**ANALYSIS OF LSD-41
MACHINERY ROOM LAYOUT.**

NPRDC Technical Note 80-7

This analysis was conducted as a preliminary step in the development of machinery rooms for the LSD-41. Tentative layouts of the machinery rooms had been prepared by both NAVSEA and the J. J. Henry Company. This report describes the advantages and disadvantages of the concepts depicted in these layouts. A key factor involved in selecting one concept over the other is the extent to which they conform to established human engineering principles and practices.

Fig. 1: NAVSEA MACH. ROOM No.1

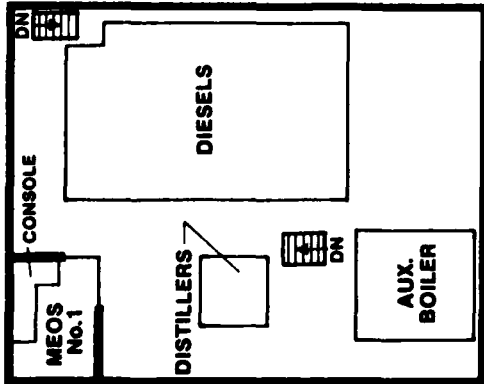
1. The NAVSEA layout permits the use of identical wrap-around consoles in MEOS #1 and #2.

2. A seated operator in MEOS #1 can view the machinery space by rotating in his chair 180°.

2. The orientation of the two MEOSs differ. In MEOS #1, the operator has his back to the machinery space; in MEOS #2, he faces the machinery space.

3. Windows should be installed in the MEOSs as depicted in Figures 1, 5, 6, and 7.

Fig. 3: J. J. HENRY MACH. ROOM No.1

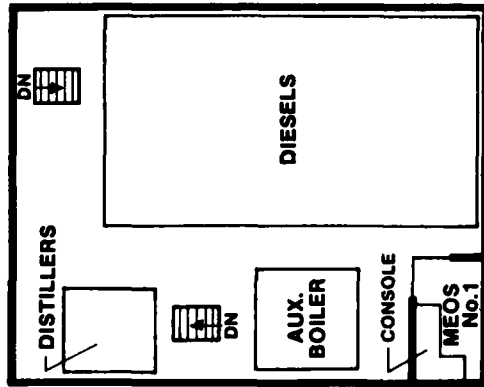
1. In both MEOS #1 and MEOS #2, the seated operator faces the machinery space. Orientations of the machinery space relative to the operator are more nearly alike than in the NAVSEA layouts.

2. Ladders to the lower level are not immediately accessible to the MEOSs.

Fig. 2: NAVSEA MACH. ROOM No.2

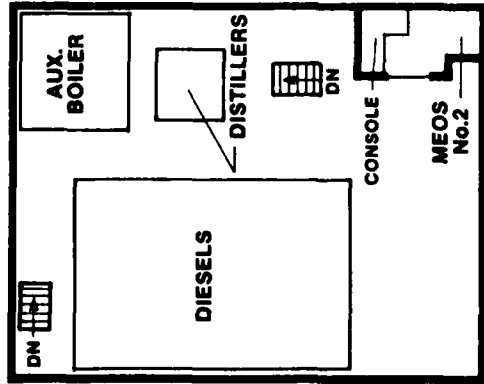
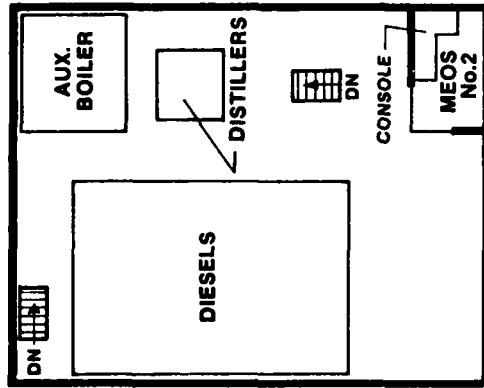
1. The console in MEOS #2 fills the entire forward area, thus preventing the installation of a window to enable the operator to view the machinery space.

If the NAVSEA layouts are adopted, the MEOS #2 should be modified to approximate the layout presented in Figure 5, which would permit the installation of forward-looking windows overlooking the machinery space. If the J. J. Henry layouts are adopted, straight consoles should be used, as indicated in Figures 6 and 7. Satisfactory results should be obtained with either the NAVSEA layouts with wrap-around consoles or the J. J. Henry layouts with straight consoles. Provided that the recommended changes are made, final selection of the layouts should be based on factors other than human engineering.

1. If the NAVSEA layouts are selected, MEOS #2 should be modified to resemble the layout in Figure 5. Wrap-around consoles may be used.

Fig. 4: J. J. HENRY MACH. ROOM No.2

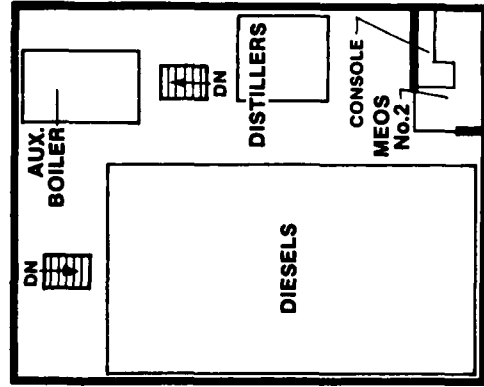
2. Configuration of the J. J. Henry MEOS #2 is better than that of the NAVSEA MEOS #2. Because of the location of the console in the J. J. Henry layout, a window overlooking the machinery space can be installed.

1. The use of identical wrap-around consoles is not feasible. If the console is placed so as to permit a window to be installed overlooking the machinery space, as in Figure 4, one wing of the console would extend out into the room. This would restrict movement of personnel and communication among personnel.
